# Building Permit Application

I'm in receipt of the building permit (B16001258), floor plans and BAT Plan for Warfield Pond Overlook, Lot 3.

**RE: Building Permit # B16001258**  
**3411 Warfield Pond Overlook**  
**Glenwood, MD 21738**

**From:** Oswald, Hank  
**Sent:** Thursday, April 14, 2016 3:13 PM  
**To:** BOBCORBETT@WILLIAMSBURGLLC.COM; CHRISWINE@WILLIAMSBURGLLC.COM  
**Cc:** Zach Fisch <zfish@FSHERI.COM> (zfish@FSHERI.COM)  
**Subject:** Warfield Pond Overlook\_Lot 3

Drawing: FINISHED BASEMENT PLAN  
Project: WILLIAMSBURG GROUP  
WELLINGTON  
WAREFIELD POND LOT 3

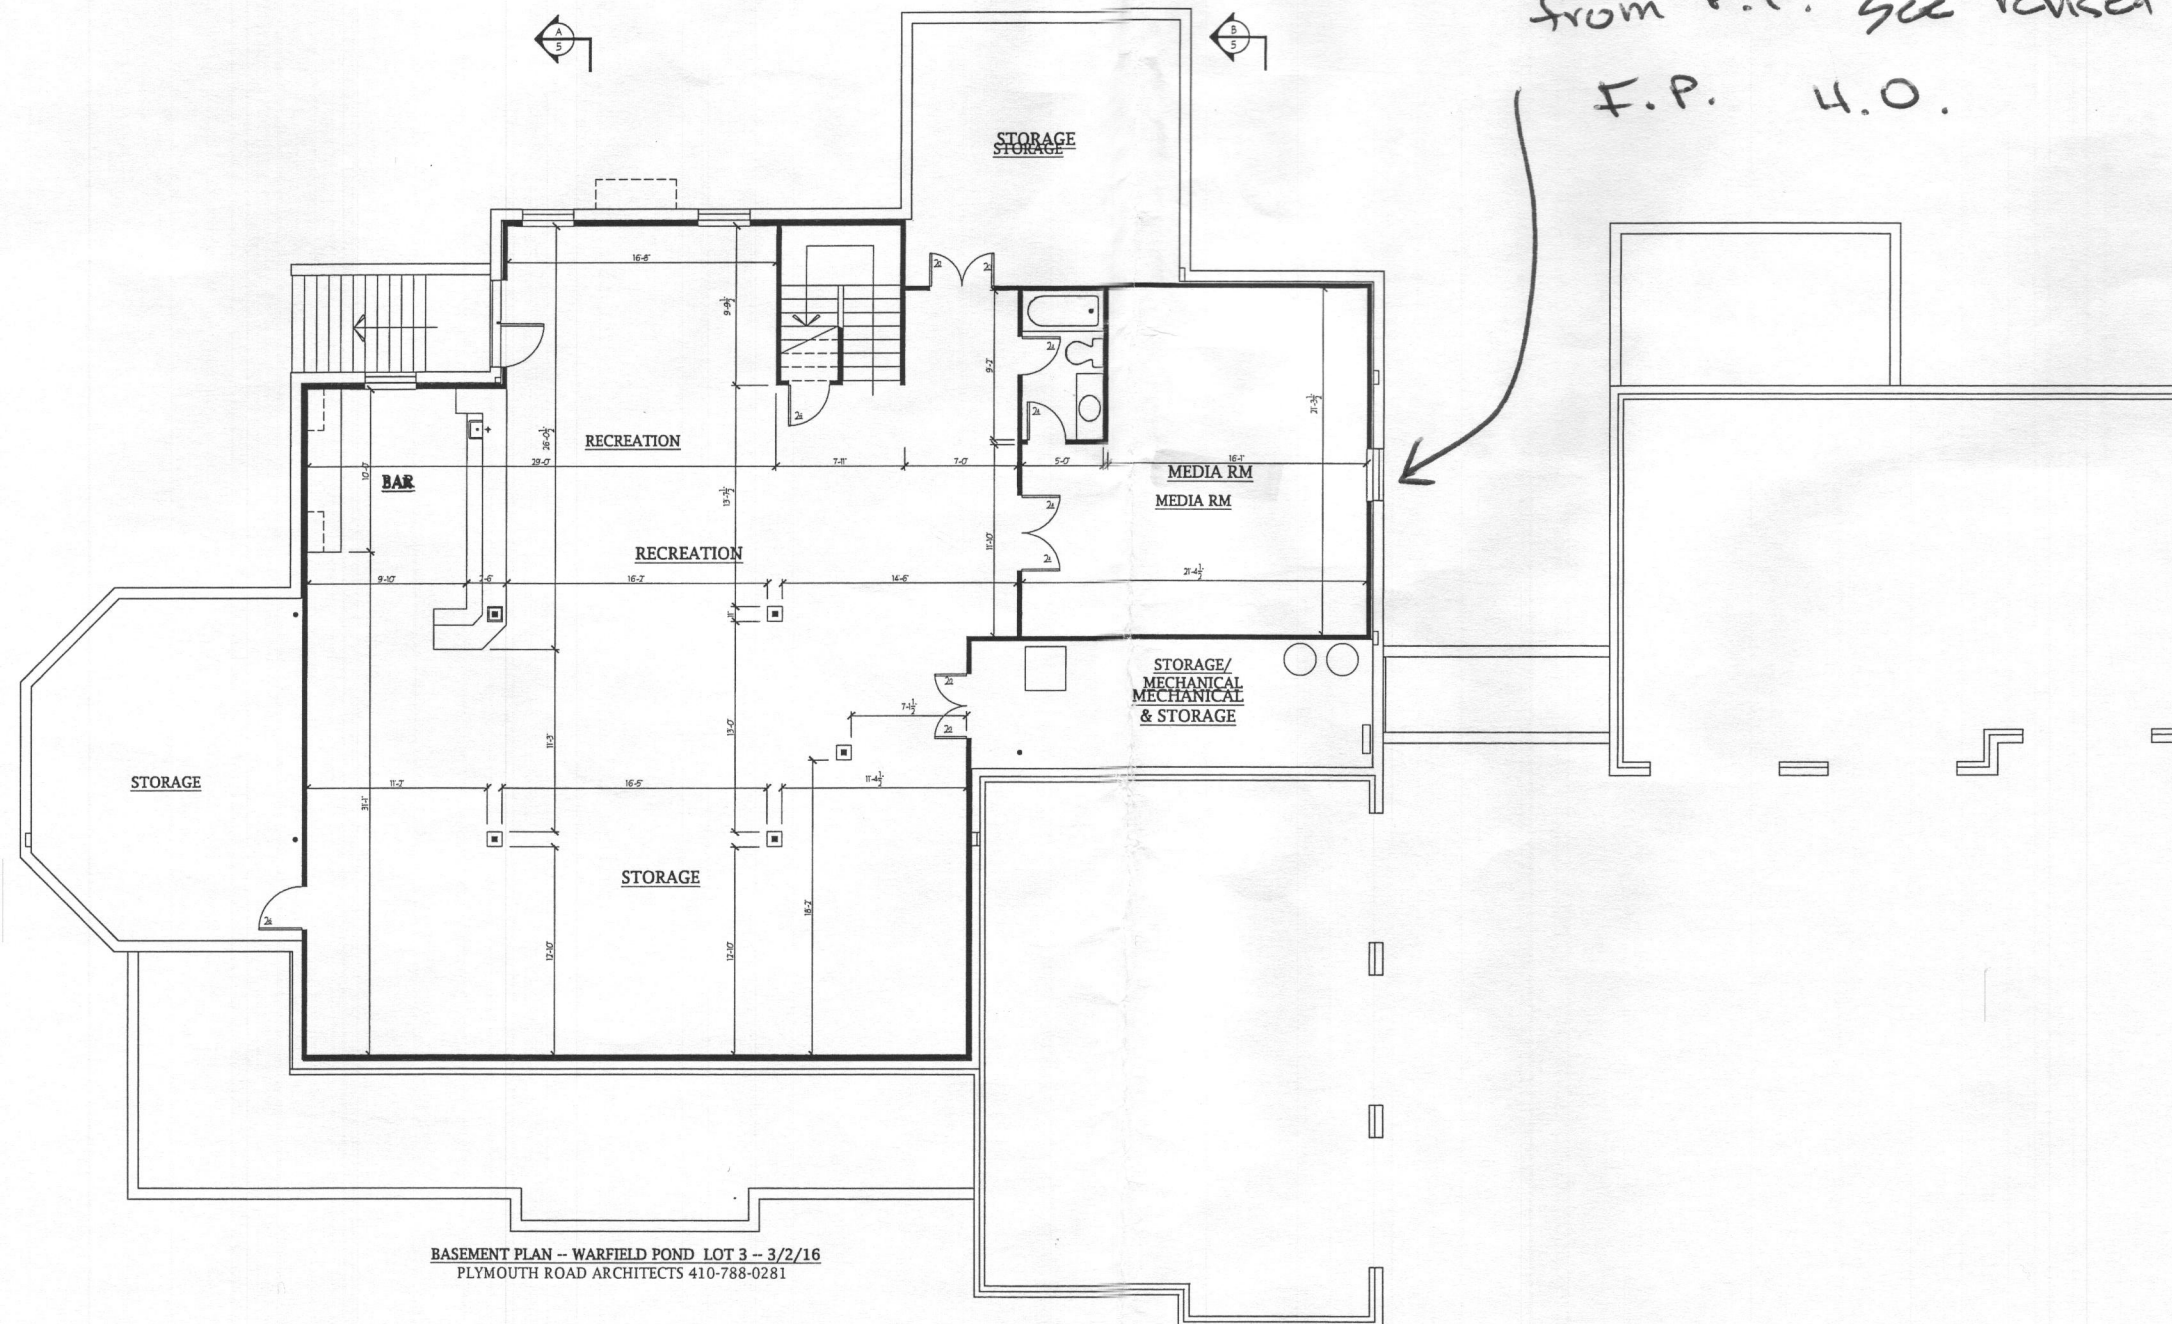
Attached, please find a copy of the Section 3.801 regarding bedroom definition. A room doesn't need to include a closet in order for it to be considered a bedroom. The media room in the basement and the library room on the first floor both have a window, door and direct access to a full bathroom and therefore are considered bedrooms. If the doors to the media room were to be removed, making it a permanent 4 foot wide opening then it would not be considered a bedroom and we are back to 5.

The BAT Plan is designed for 5 bedrooms and the floor plans show 6 including the Media Room in Basement, Library on 1<sup>st</sup> Floor, and 4 bedrooms on the 2<sup>nd</sup> Floor. The building permit indicates 4 BR's. Either the FPs or the BAT plan will have to be modified to match-up (Increase BAT bedroom capacity to 6 or reduce BR count to 5).

4/18/16 Window removed  
from F.P. See revised  
F.P. U.O.
